Work Order ID 128371

Item ID: D350-607-511 Accept ***N900040100*** Setup Start ***NS1***
 Revision ID: Stop ***NS2***
 Item Name: Quick Release Basket Mounting Spacepod™ & Squirrel Cheek Fits LH or RH
 Start Date: 1/22/15 Start Qty: 1.00 ***1*** Cust Item ID:
 Required Date: 1/30/15 Req'd Qty: 1.00 ***1*** Customer:
 Reference:

DART SERVICE INSTRUCTION

TO AMEND INSTALLATION INSTRUCTIONS D350-607-3 Rev.D,
INSTALLATION INSTRUCTIONS D350-607-4 Rev. C AND
INSTRUCTIONS FOR CONTINUED AIRWORTHINESS ICA-D350-607 REV. 6
REF TCCA STC: SH94-14
REF FAA STC: SR00213NY
REF EASA STC: EASA.10016996
REF BRAZILIAN STC: 2007S03-03/-04/-05/-06

FIGURE 1: INSTALLATION OF D4775-041 FWD STRUT

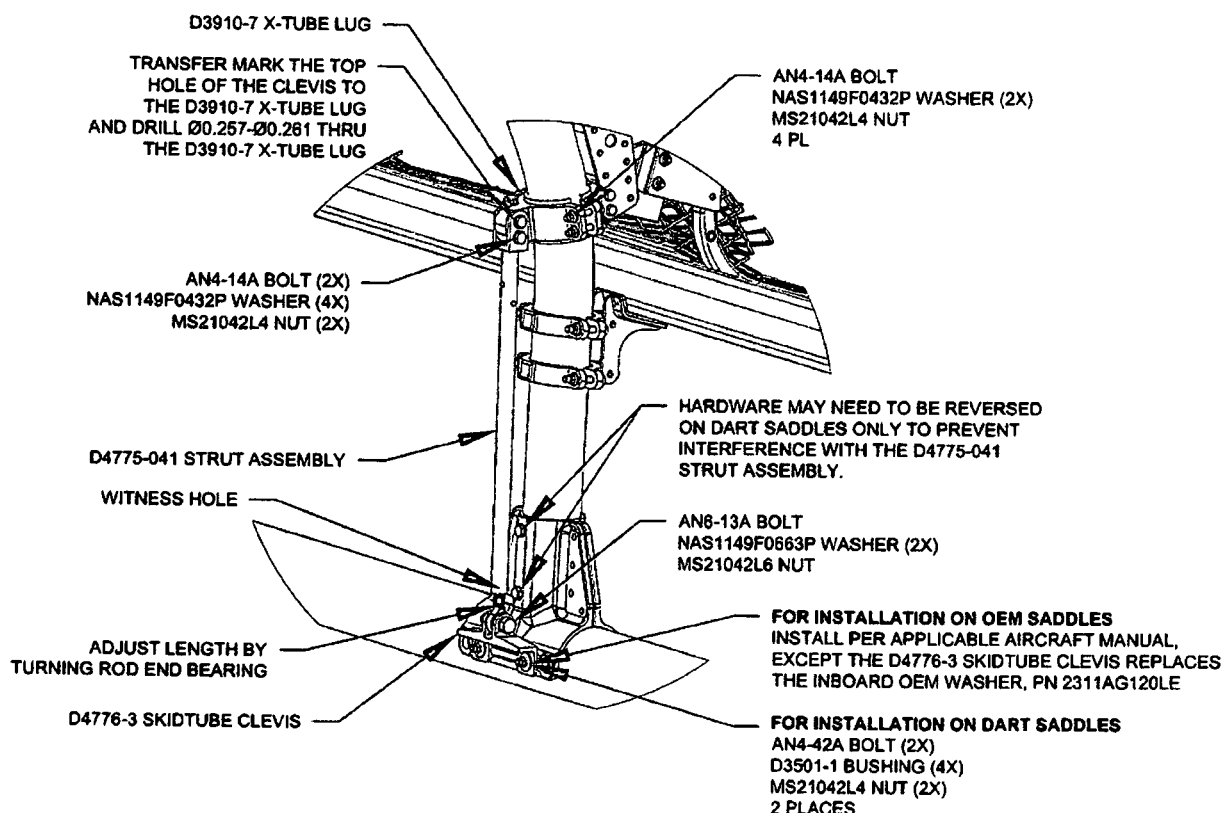
- 3.1 Substitute the Forward Lower D3910-5 X-Tube Lug with the D3910-7 X-Tube Lug as shown in Figure 1.
- 3.2 Install the forward D4775-041 Strut Assembly. Transfer mark from the upper hole on the clevis of the D4775-041 Strut Assembly to the D3910-7 X-tube Lug and drill thru the lug $\varnothing 0.257$ - $\varnothing 0.261$ as shown in Figure 1. Touch up chemical conversion coating per MIL-DTL-5541. Check the witness holes located at the bottom end of the D4775-041 Strut Assemblies to ensure that the thread from the rod end extends past the witness hole.
Torque MS21042L4/-4 nuts to 50-70 in-lbs (5.7-7.9 N-m). Torque MS21042L6/-6 nuts to 160-190 in-lbs (18.1-21.5 N-m).
- 3.3 Complete the installation in accordance with Installation Instructions D350-607-3 Rev. D or D350-607-4 Rev. C.
